Re: Wellington North Solar Farm SSD-8895 – Request for Information (RFI) 17-382

NGH have prepared responses to the RFI for Wellington North Solar Farm SSD-8895 on behalf of Wellington North Solar Farm Pty Ltd (“the proponent”), as discussed in consultation with AGL and DPIE. Points have been grouped together where the requests were of a similar theme. Each information request from DPIE is provided in **bold italicised** text, above the proponent’s response.

Figure 2 Haulage Route as described in the Traffic Assessment for Wellington North Solar Plant

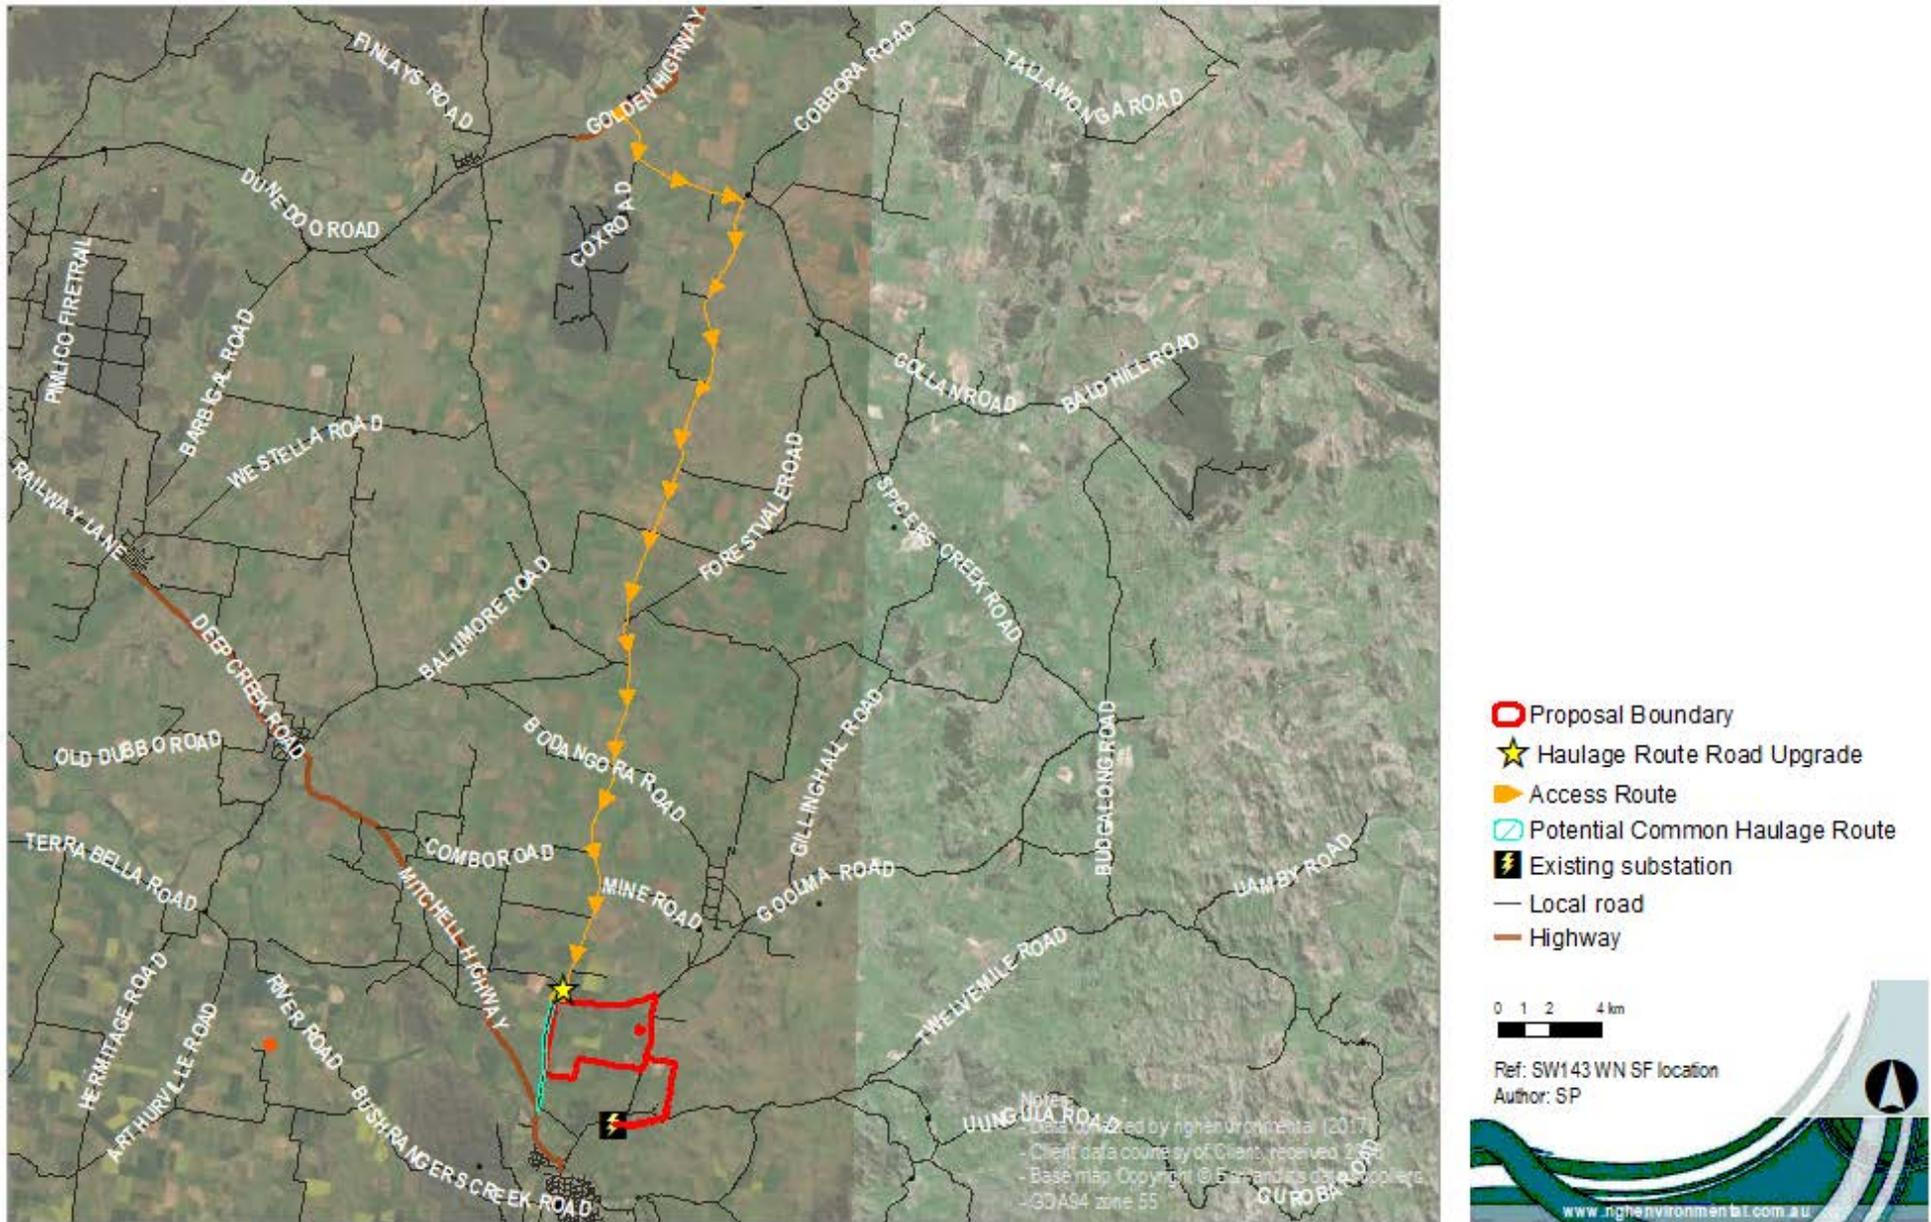
Provide a figure demonstrating the proposed transportation route, and identifying the zone of potential cumulative traffic impacts with Maryvale Solar Farm.

The proposed transportation (haulage) route is provided in Figure 2 below. The area of highest potential cumulative traffic impacts for heavy traffic has been identified as a short section of Cobbora Road (highlighted as the potential common haulage route on Figure 2 below) located between Maryvale Road and Campbells Lane. It is noted that only the transmission line heavy vehicles may have a potential common haulage route between Campbells Lane and Bella Vista Lane/Mitchell Highway. The cumulative impacts would also depend on construction timing for the proposed and all surrounding developments and direction of travel for heavy vehicles for the transmission line which may take an alternate route of Campbells Lane to Goolma Road therefore avoiding potential conflicts between Campbells Lane and Bella Vista Lane/Mitchell Highway.

Figure 4 View from N11 representing VP09 (MIOR Landscape Architects, 2018)

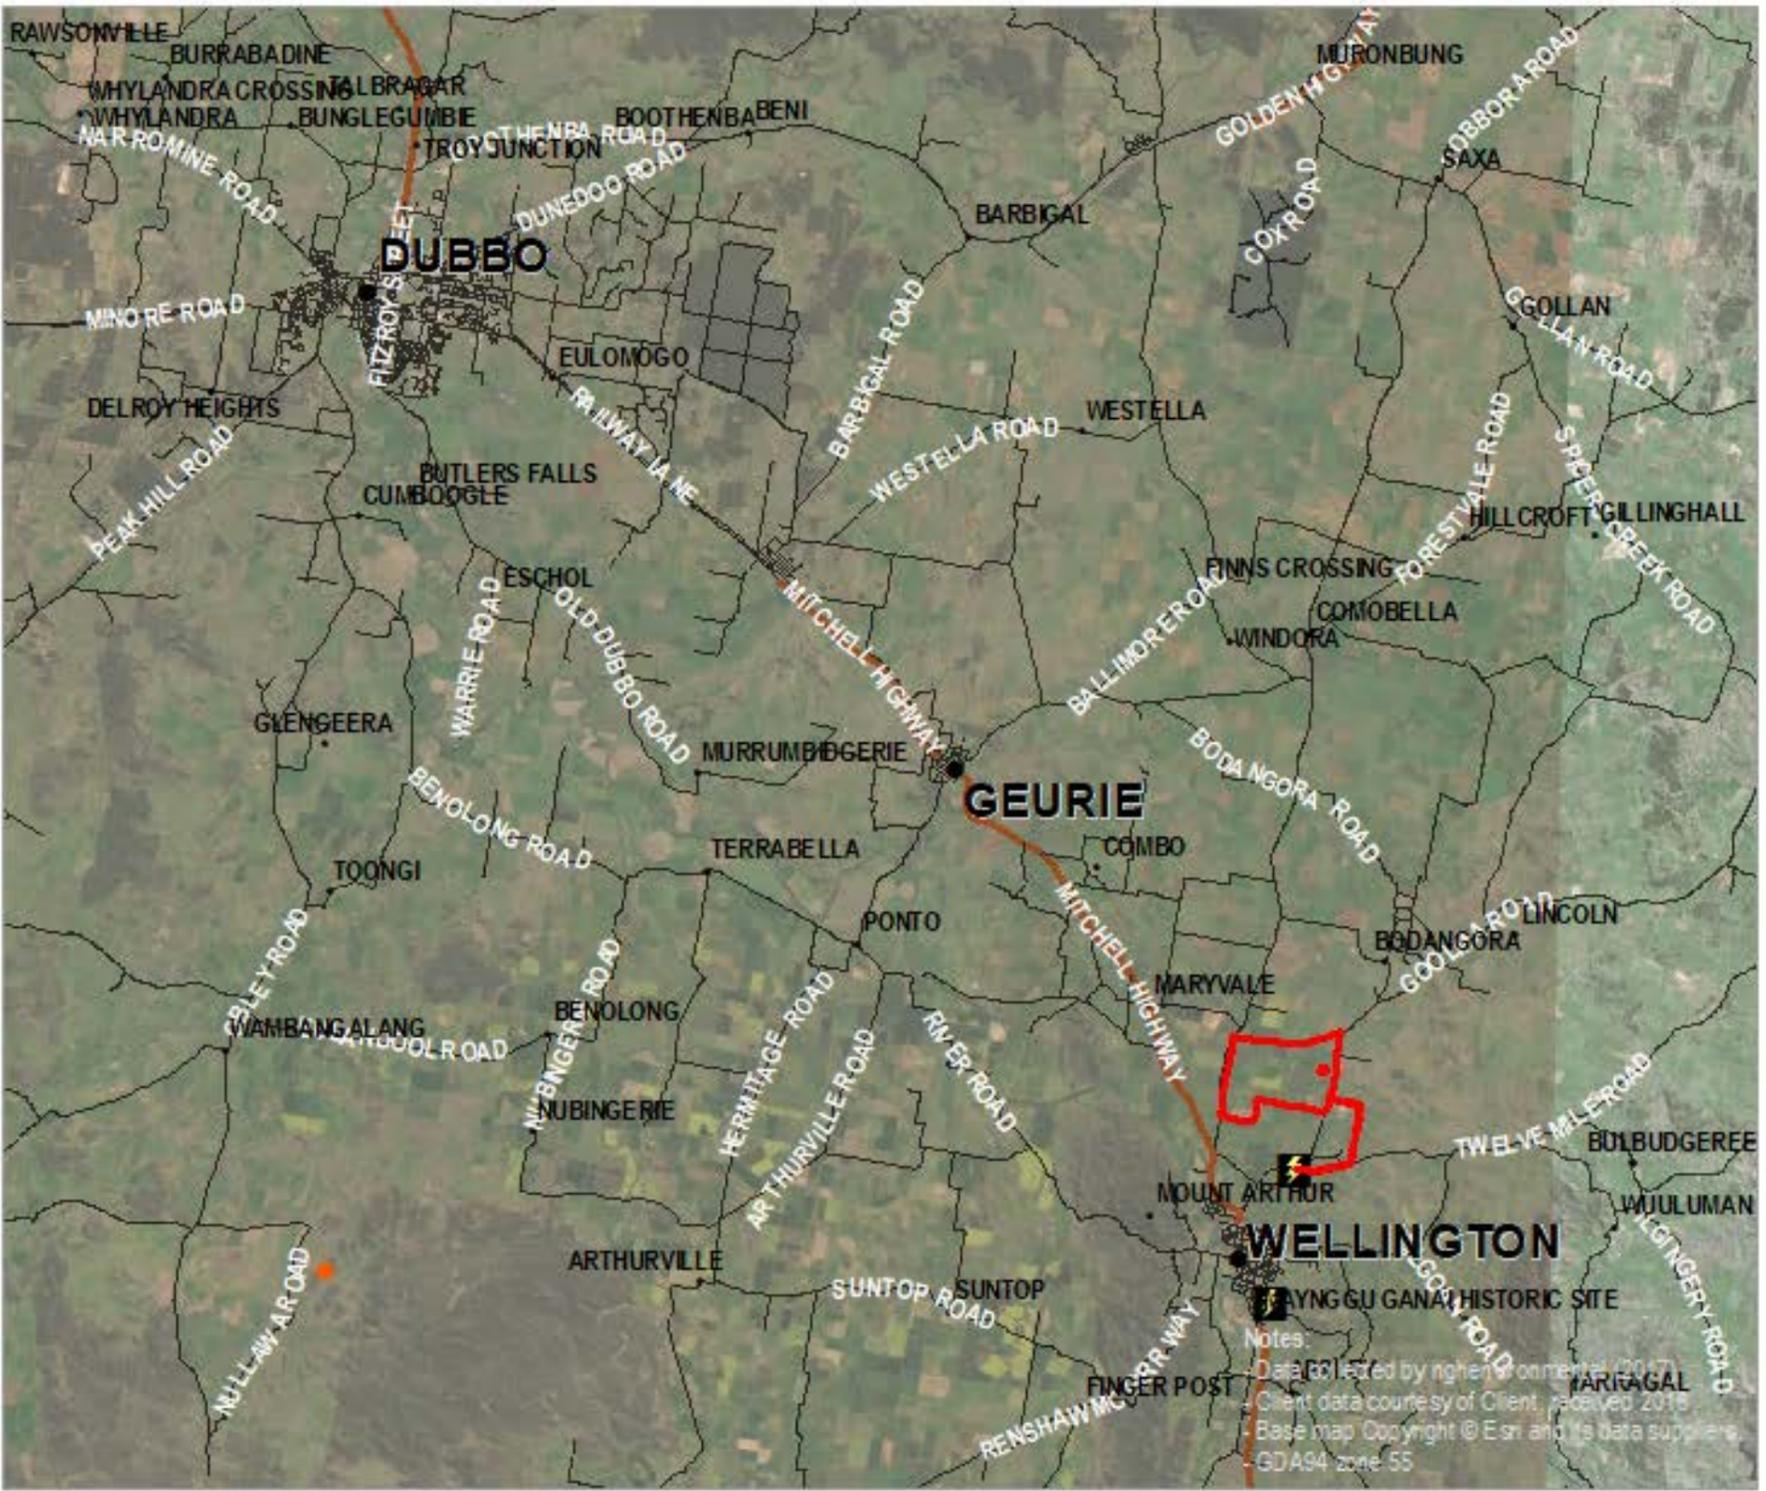
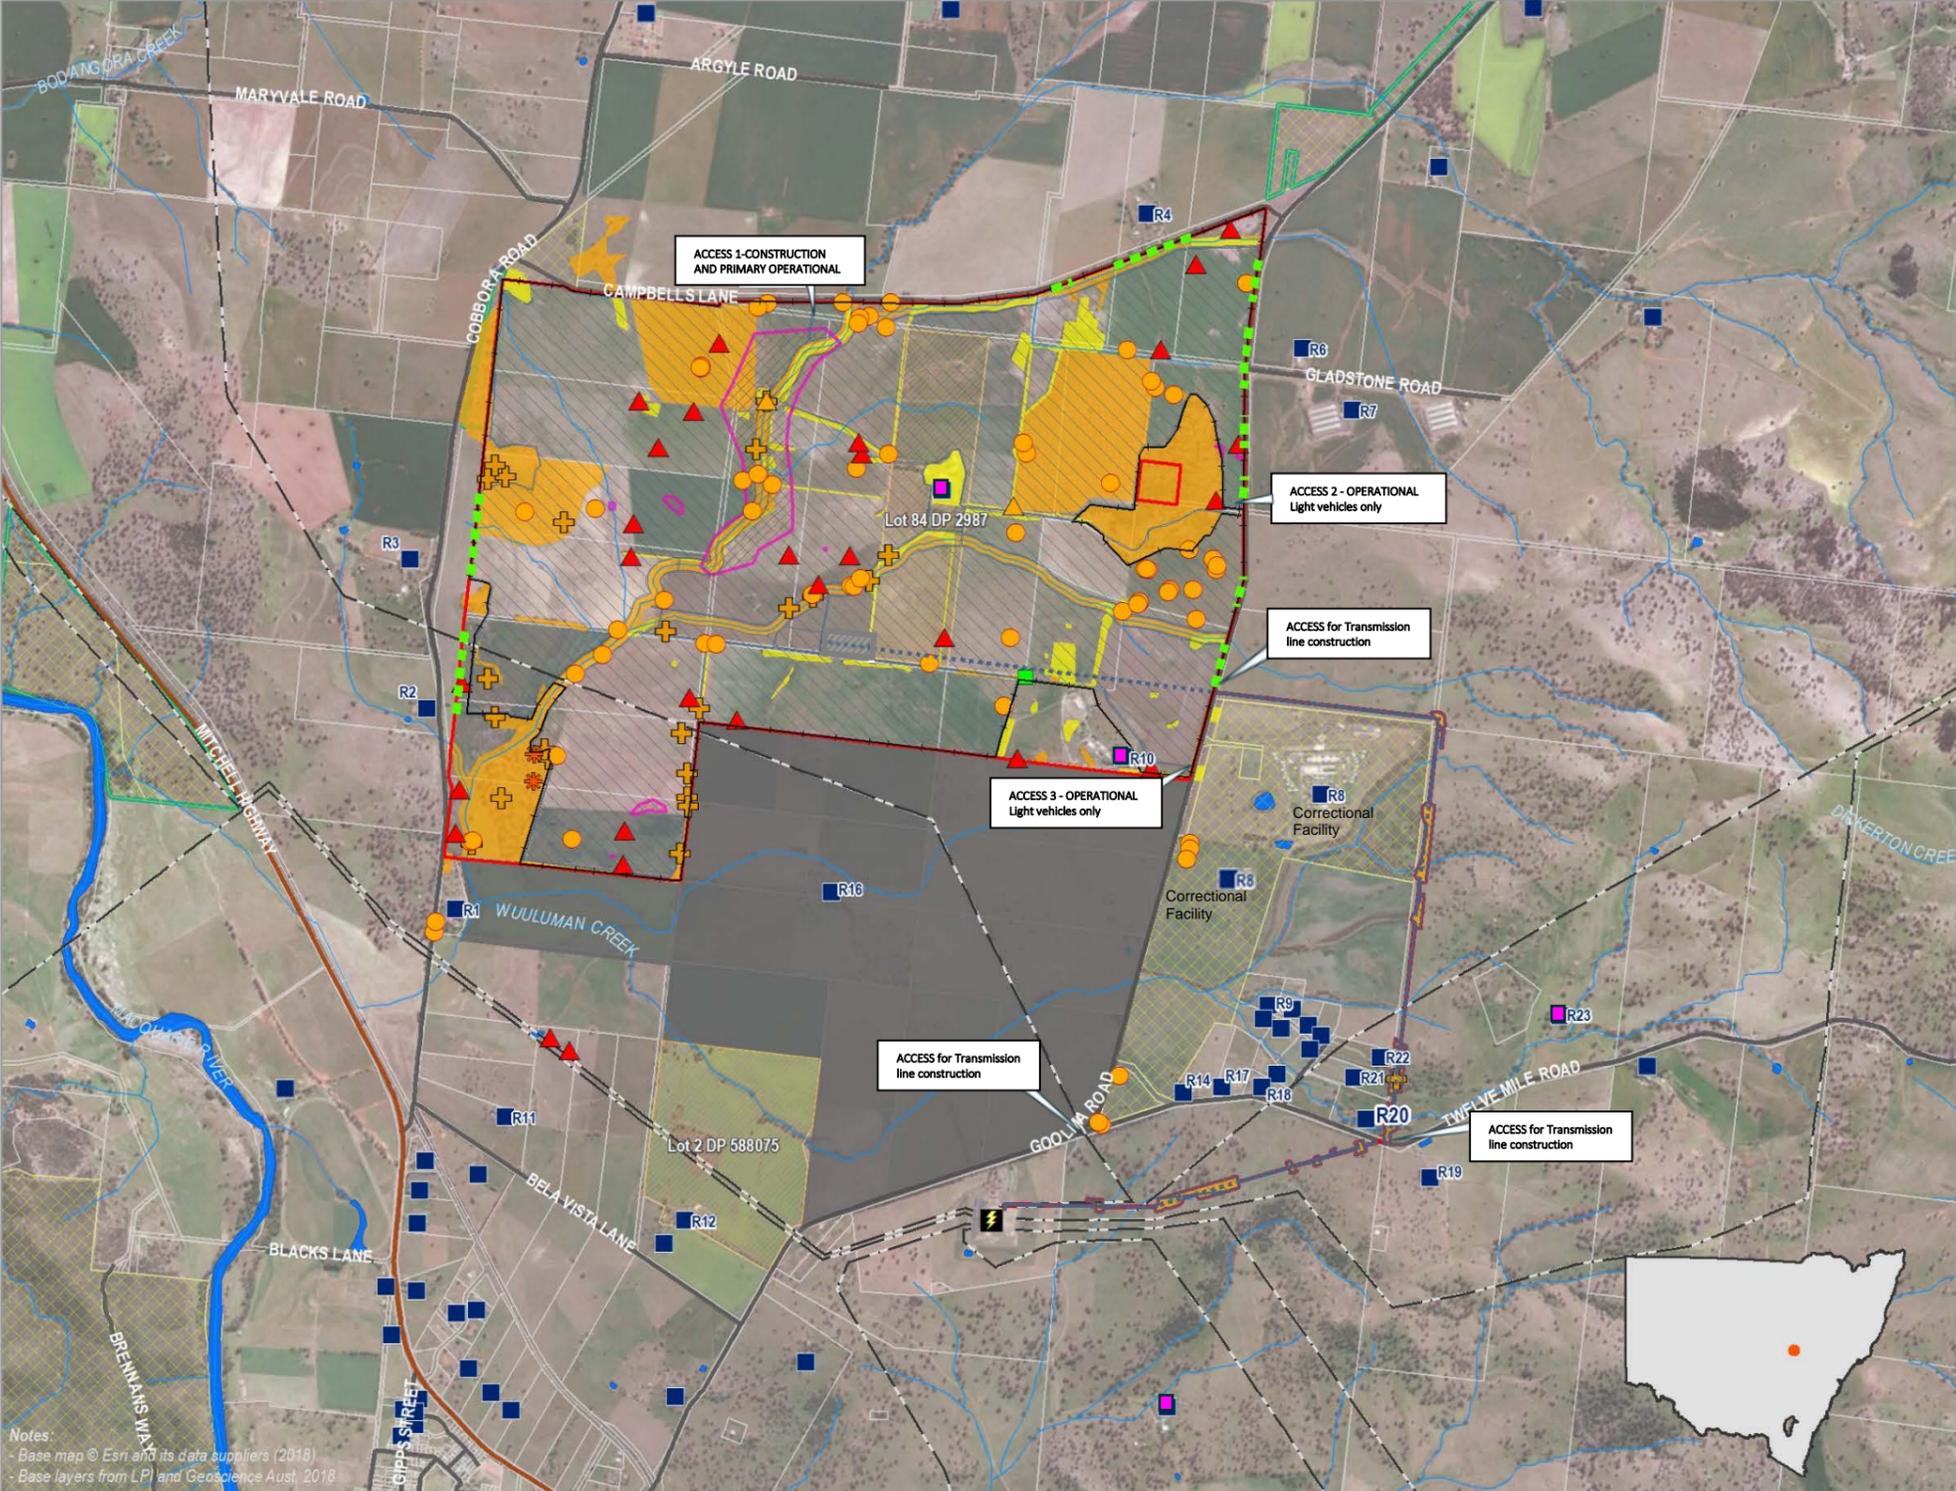
As the representative viewpoint for R4, provide a photomontage of the visual impact of solar farm infrastructure from VP09:

Figure 3 above has been provided to show the location of the montage for VP09. The montage from N11 is provided at Figure 4 below. Figure 5 shows the impact from the road is the greater impact.
